Force calculations on Opera models of SolID magnet system

Jay Benesch 2 December 2016

Zhiwen's suggestions

My current baseline

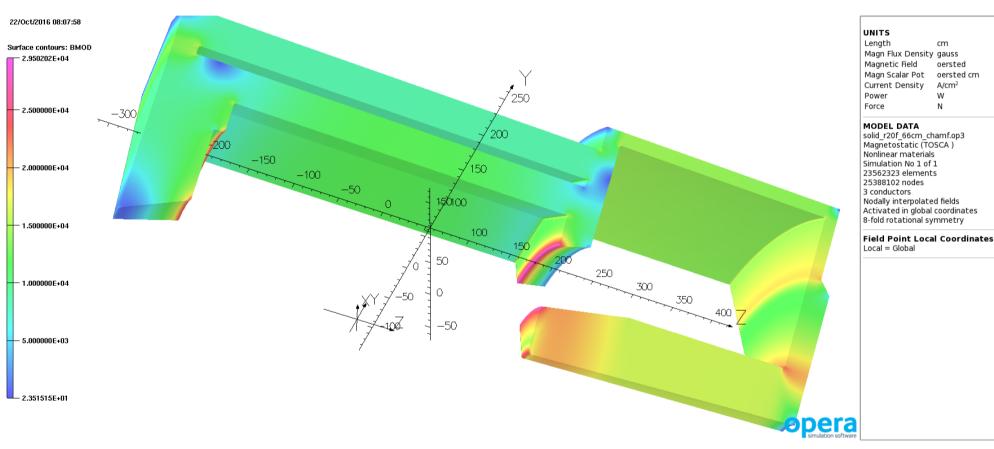
- Downstream collar enlarge by by 15cm in z (engineering need for support)
- Endcap move 15cm downstream and enlarge 30cm (SIDIS setup needs room)
- Endcap nose back reduce 5cm in r (EC hexagon module needs room)
- 6cm gap between downstream collar and endcap (let cable out, more cable out at back needed)
- Main impact, PVDIS EC large angle performance

Upstream plug is 26" with 24 degree conical hole. Downstream coil collar is 14" thick. Net force on coil 23 kN vs 196 kN allowable. ~ 100 cm OD by ~ 6 cm Z upstream solenoid to null stray field for He3

Errors in detector volumes

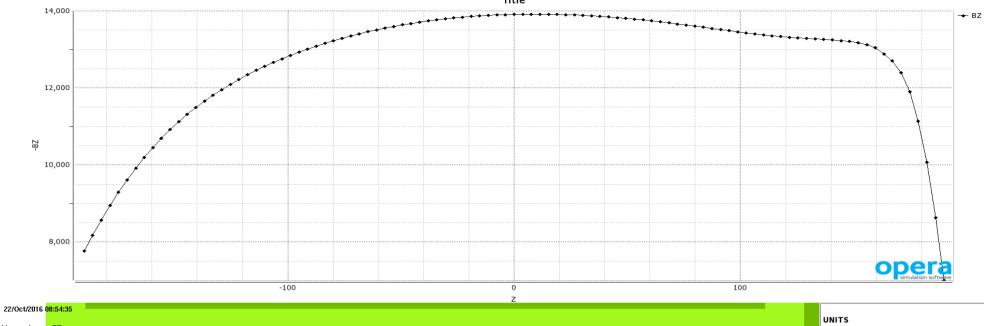
Errors over 1% of local B field not shown

- Do I have to remove steel from cone, and therefore from upstream plug, to allow for detector mounts? Is 90 cm OR OK?
- What does "Endcap nose back reduce 5cm in r (EC hexagon module needs room)" mean? Give me a number.
- What interior length is needed for endcap cylinder? 261 cm now.
- Is longer/heavier cone compatible with Whit's overall endcap support and floor rail system?
- Can endcap cylinder wall be increased to 6.5" from 6" to lower stray field inside it?
- Can plate at end of cylinder be increased to 6.5" to reduce peak field in steel?
- Are field errors on previous page OK?
